Village of Arlington Heights
Conceptual Plan Review Committee
Community Room, 3rd Floor
Arlington Heights Village Hall, 33 S. Arlington Heights Rd.
September 25, 2019
7:00 PM

Item: 716 N. Dunton Ave. Subdivision - T1674

VILLAGE OF ARLINGTON HEIGHTS **STAFF DEVELOPMENT** **COMMITTEE REPORT**

Temp File Number: T1674
Project Title: 716 N. Dunton Subdivision
Address: 716 N. Dunton Avenue
PIN: 03-29-115-019

Appendix 1: Surveyed Lots

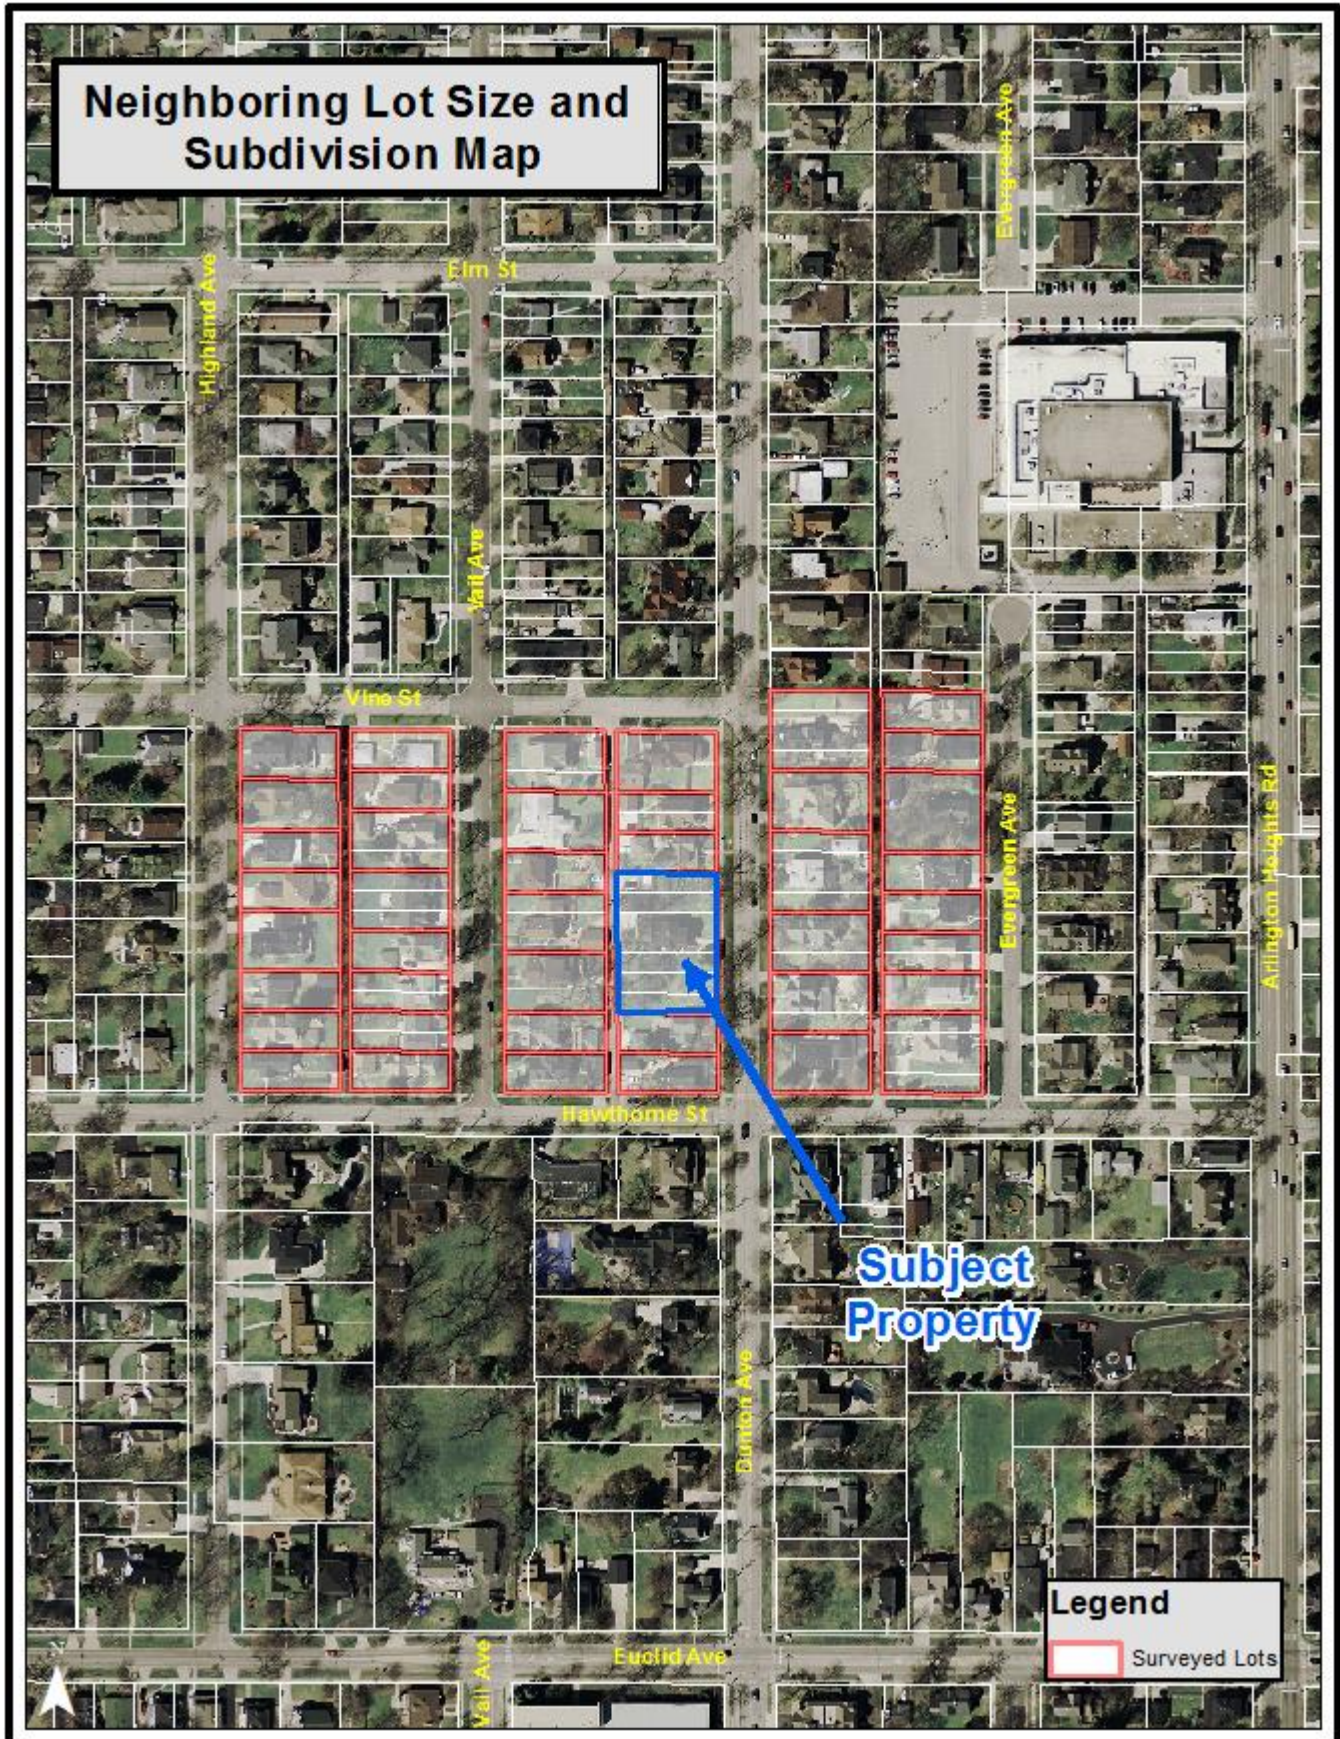
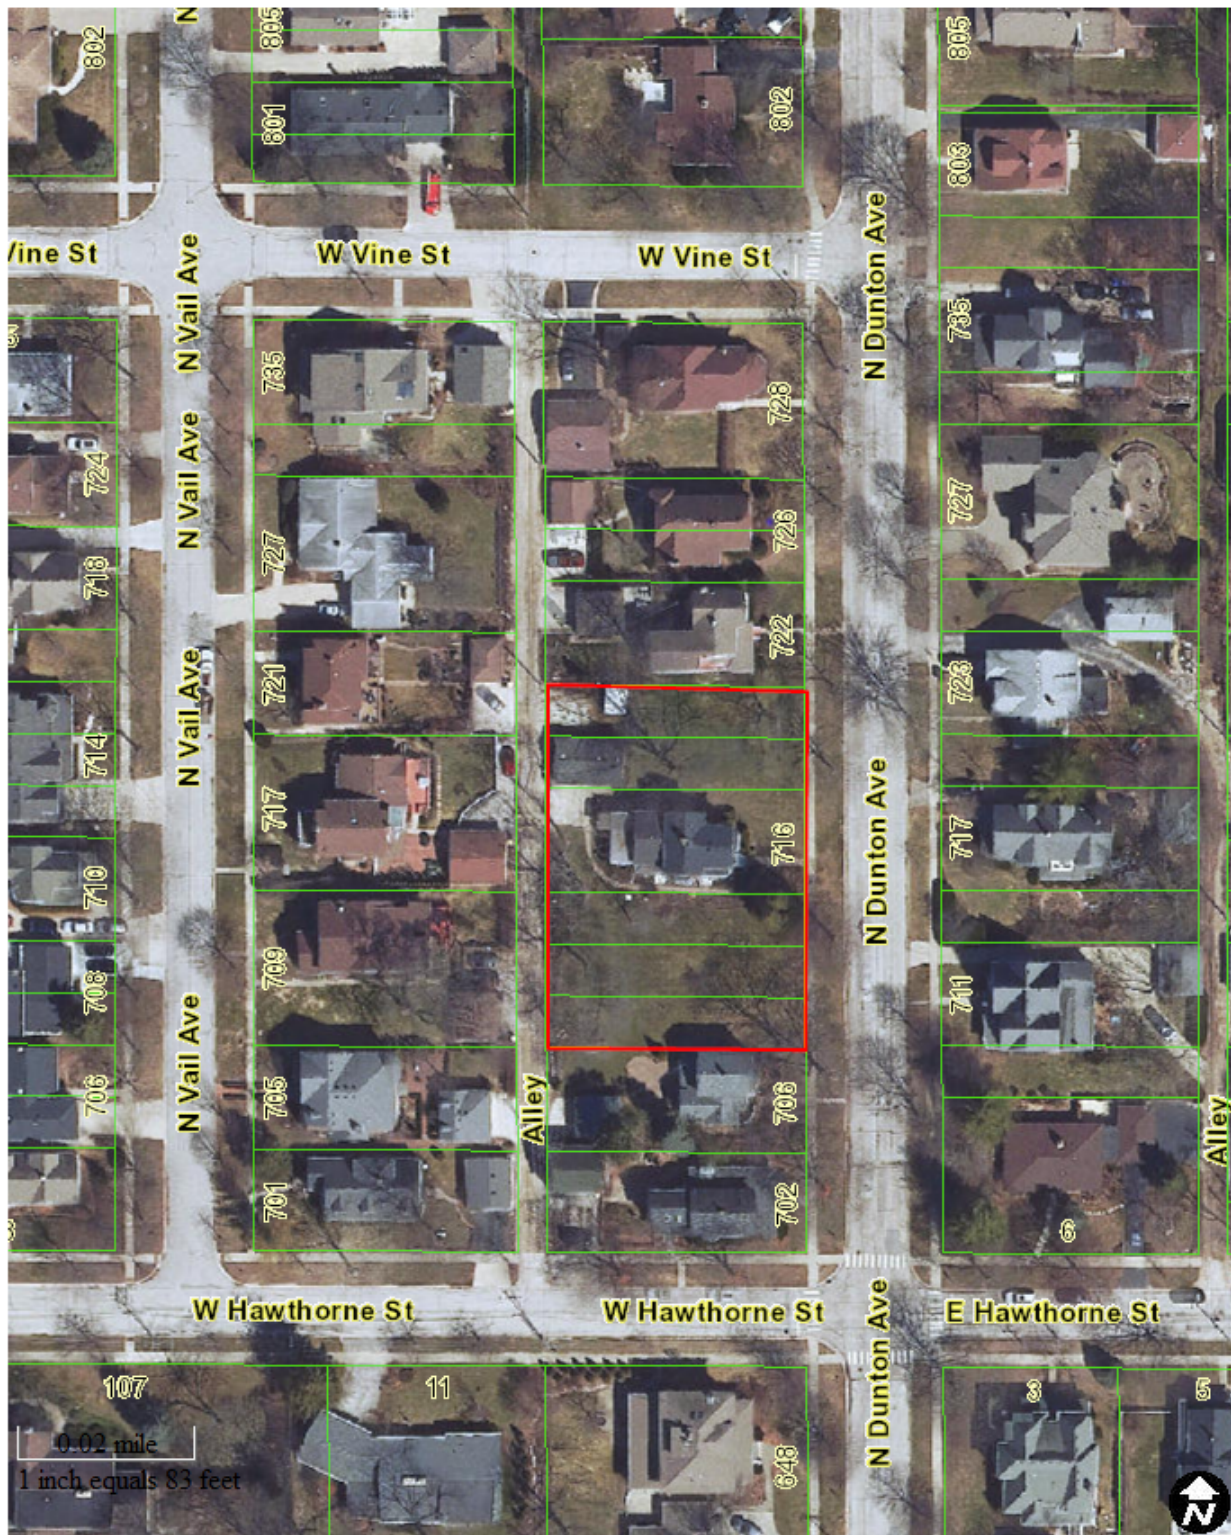
In order to evaluate the appropriateness of the proposed subdivision, staff will complete a detailed analysis of the lot sizes within the vicinity to determine if the proposed lot sizes are compatible with the existing lot sizes in the neighborhood. Based on a preliminary analysis, the proposed lots are smaller than the average lot size within the neighborhood. A total of 43 lots were surveyed (including the subject lot), as shown in **Appendix 1** at the end of this report. A summary of the findings are shown below:

Based on the surrounding lot sizes, the Staff Development Committee believes that the subject property is large enough to support only two lots, not three as proposed. The southern lot, proposed at 9,375 square feet in size, is acceptable. However, staff recommends that the two proposed 6,250 square foot lots be combined into one 12,500 square foot lot that would contain the existing house. Alternatively, this lot could be 9,375 square feet in size, and the northern 25' wide portion could be sold to and consolidated with the property to the north (722 N. Dunton), which would make all three properties the same size. If the proposal were to proceed as proposed (with subdivision of the subject property into three lots), a new garage would be required on the middle lot that contains the house, since the existing garage for this house would need to
